Contract Reference: Engineering, Procurement and Construction Contract between Nepal Water And Energy Development Company Private Limited (NWEDC) and Doosan Heavy Industries & Construction Co. Ltd for the Engineering, Procurement and Construction (EPC) for the 216 MW Hydropower Plant at Upper Trishuli -1, Nepal

Subject: Submission of Review Note on Excavation and Initial Support Drawings of Investigation Tunnel for Powerhouse

REVIEW NOTE

Contractor	**Doosan Heavy Industries & Construction Co., Ltd.**		
Title of the Document	Excavation and Initial Support Drawings of Investigation Tunnel for Powerhouse		
Document No.	UT1-C-385-CVL-DG-65002-01 UT1-C-385-CVL-DG-65002-02	Revision	A
Date of Documents	01.09.2021	Received Date	01.09.2021
Transmittal Form No.	UT1-HEP-DHI-D-0038		
Previous Review Date/Status	N/A	Prev. Review Note No.	N/A
Review Note No.	**RN-0011**	**Present Review Date**	**20.09.2021**
		Present Review Status	**RR**

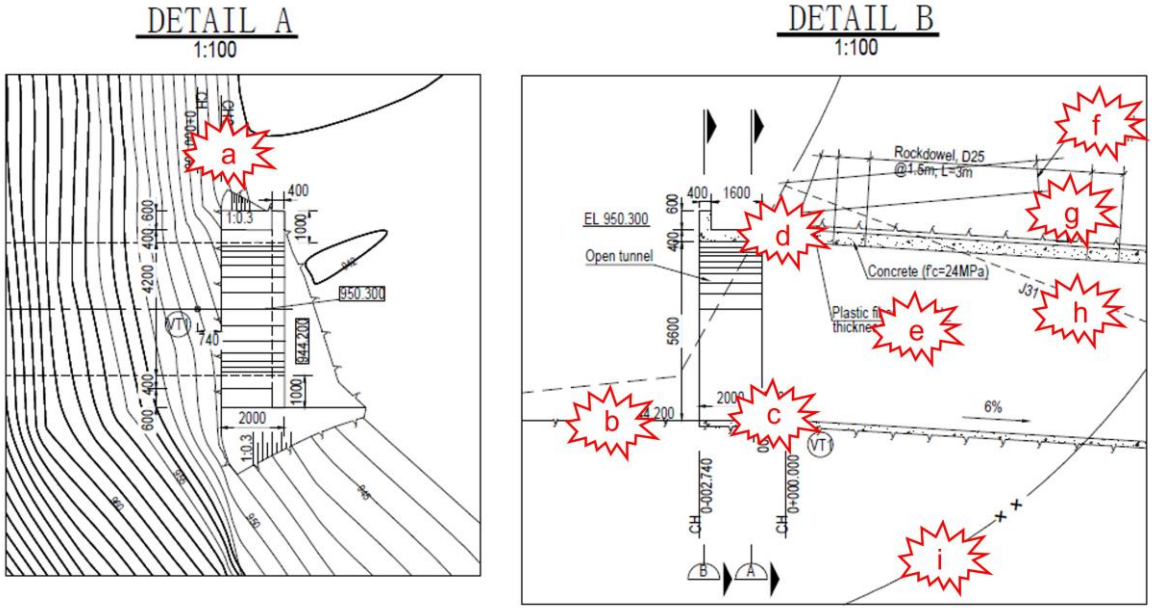
a) Chainage is given as 0-000.740, which is confusing. Generally, chainage is 0+000 where the tunnel enters rock. Consider and revise accordingly.
b) Indicate the assumed boundary soil/rock.

c) The tunnel is drawn horizontal at the portal and from Ch. 0+000.000 it slopes with 6%. This would require a kink in the reinforced concrete liner, which is very inconvenient when shuttering and reinforcing the concrete liner. In practice, it makes it also difficult to install the 5 m long spiles at the right angle. Generally, the tunnel should have one gradient in the portal section where the tunnel is concrete lined. Revise accordingly. The end of the portal concrete liner is not specified. The profile of the “Support Type of Tunnel Entrance Section” indicates, however, that it reaches to Ch. 0+007.000. Revise accordingly.

d) The rock where the spiles are installed need to be cut vertical. Consequently, the vertical portal cut slope get higher and the actual portal moves slightly inward. Steel support is generally required for the portal and for the first meters (steel ribs or lattice girder). The spiles shall stick out by 300 mm and a stell rib needs to be placed underneath the spiles. The sticking out spiles need to be fully embedded in fibre reinforced shotcrete (as shown in the sketch below).

e) The thickness of shotcrete is around a portal generally > 100 mm. Only in Class I (or II) it may be 100 mm or even omitted (in massive rock, Class I).

f) A second row of spiles is not required (only in class IV or V it may be required). The second row is hence optional. Indicate this.

g) The “look-out angle” of the spiles shall be 4° at a maximum.

h) Use in all rock engineering documents (drawings/reports, excel-lists etc.) the notation of geological structures as follows: for planar structure use dip/dip direction (e.g., 46/330 or 70/065), and for linear structures use plunge/trend (e.g., 70/020 or 34/278). This is necessary as such noted data can directly be used by the engineer for calculations, e.g., wedge stability calculations for slopes or underground excavations.

i) Omit this line of rock weathering grade as it is purely speculative.

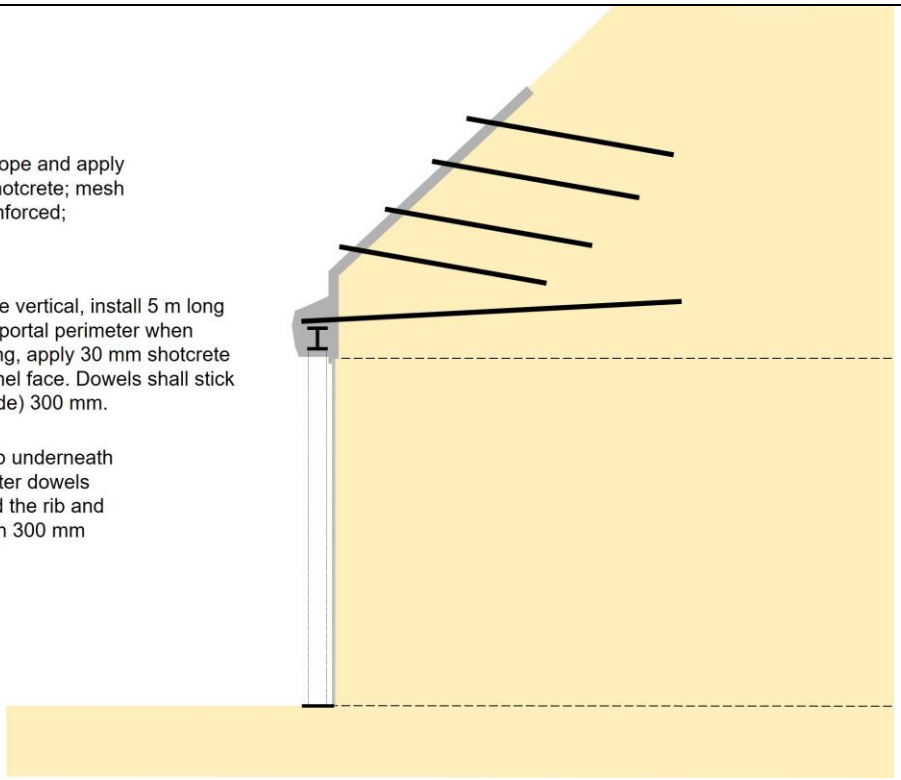
1. Clean slope and apply 100 mm shotcrete; mesh or fibre reinforced; dowels.
2. Cut slope vertical, install 5 m long dowels on portal perimeter when slope cutting, apply 30 mm shotcrete skin at tunnel face. Dowels shall stick out (protrude) 300 mm.
3. Install rib underneath the perimeter dowels and embed the rib and dowels with 300 mm shotcrete.

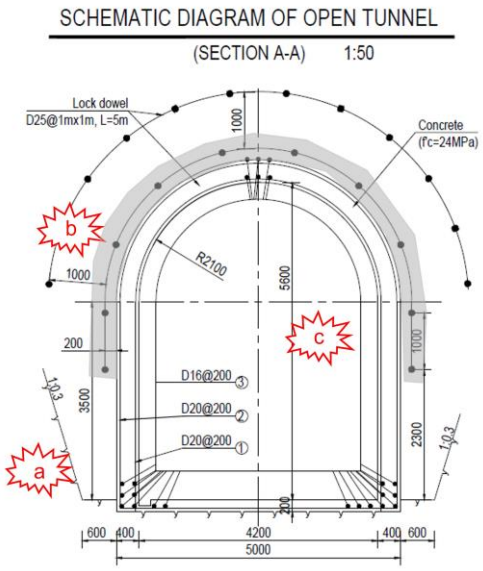
a) The lateral space between the concrete liner and the rock slope of only 600 mm appears to be in practice too small. Revise.

b) Second row only indicative, 300 mm out of first row of spiles (= dowels), and staggered arrangement. Spacing of spiles shall be 400 mm as in the inner row.

c) Shadow the area that is reinforced concrete and indicate (similarly as in the figure left, where the area that is covered with 300 mm reinforced shotcrete is indicated).

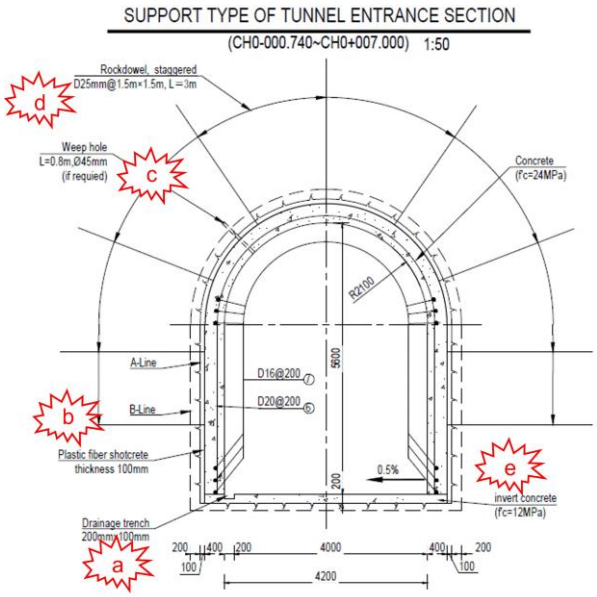
a) 100 mm of concrete below ditch is too thin. It requires excavating 100 mm more into rock.

b) Indicate that thickness of fibre reinforced shotcrete depends on rock class.

c) Weep holes in a reinforced tunnel liner at the portal are generally not required. However, contact and cavity grouting after concreting need to be indicated.

d) Indicate that spacing of dowels depend on rock class.

e) Invert concrete need to be (mesh) reinforced.

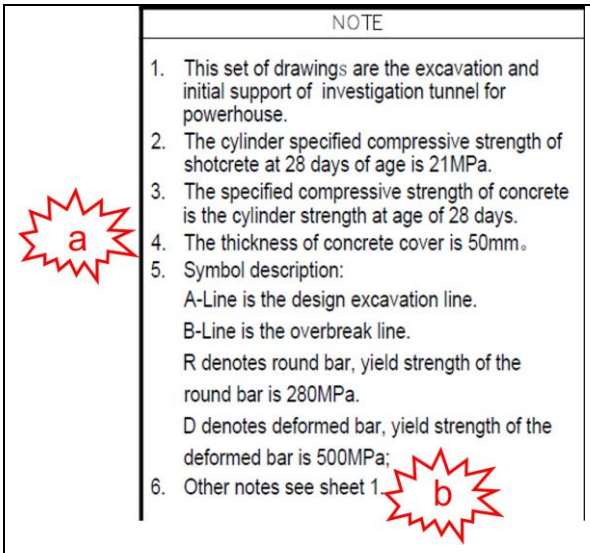
a) The thickness of concrete cover of steel reinforcement shall be 50 mm.
b) See sheet 2 not sheet 1.

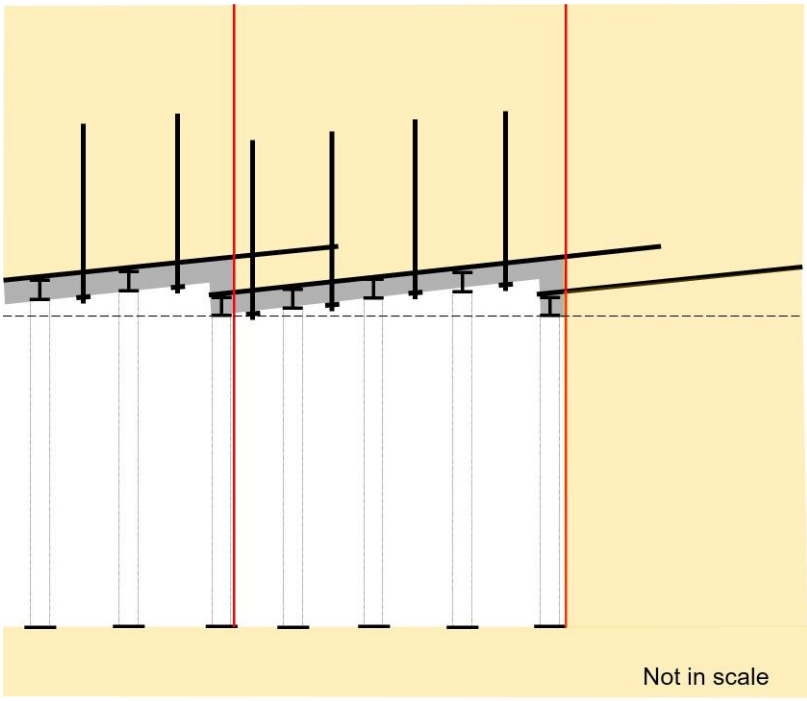
This sketch demonstrates schematically and in principle driving of a tunnel by fore-poling with spiles (dowels), which is practically feasible. The red lines indicate the location of the tunnel face, when new spiles (dowels) are installed. For tunnels smaller than 10 m in diameter the most economic and safe set-up is as follows: the length of spiles should be 6.0 m. The overlap of subsequent rows of spiles should be 1.7 m. The look-out angle of spiles should be 4°, only. 6.0 m long dowels still allow directional drilling to create a canopy. This length of spiles also allows reasonable distances between faces where spile installation is required. Note that installation of spiles is very time-consuming. In addition, this geometrical set-up allows to place under the newly installed spiles, which are sticking out (protruding) 300 mm, a supporting steel rib, which is then embedded in shotcrete. This is the same statical principle as applied at tunnel portals. Furthermore, this set-up allows grouting in-between the spiles (dowels).

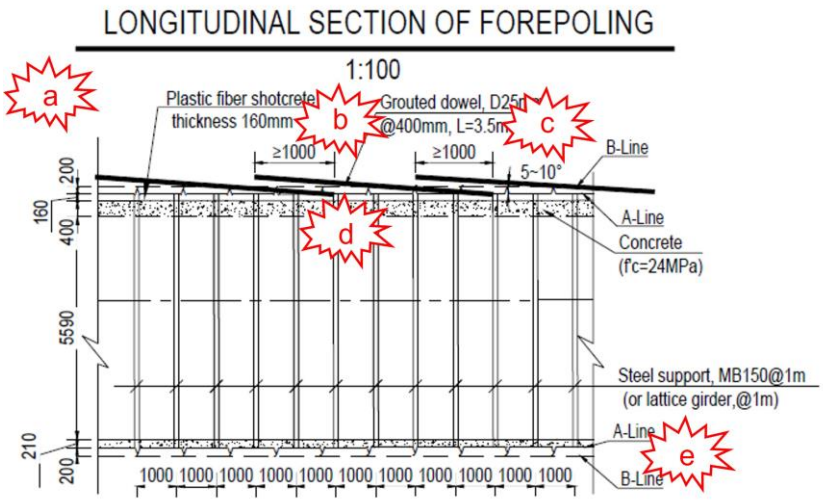
a) Modify generally the drawing as suggested above or similar. Drive direction always from left to right.
b) Indicate rock dowels that are installed in the roof.
c) Indicate weep holes.
d) Clearly define out-look angle and overlap of spiles
e) Indicate longitudinal steel bar connections between ribs. Number the steel ribs as they have different size. (e.g. 1,2,3,4,1,2…)

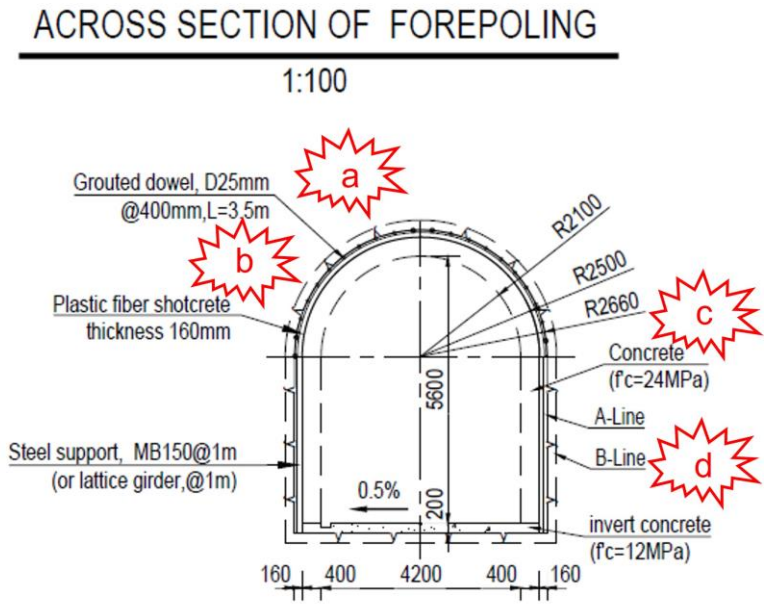
Same/similar comments as above apply.

a) Add the profiles with the different geometry of the steel rib.
b) Indicate dowels in roof and sidewall and show staggered dowels.
c) Show weep holes with PVC-pipes and geotextile as Class V rock will always contain many fines.
d) Invert concrete needs to be (mesh) reinforced.
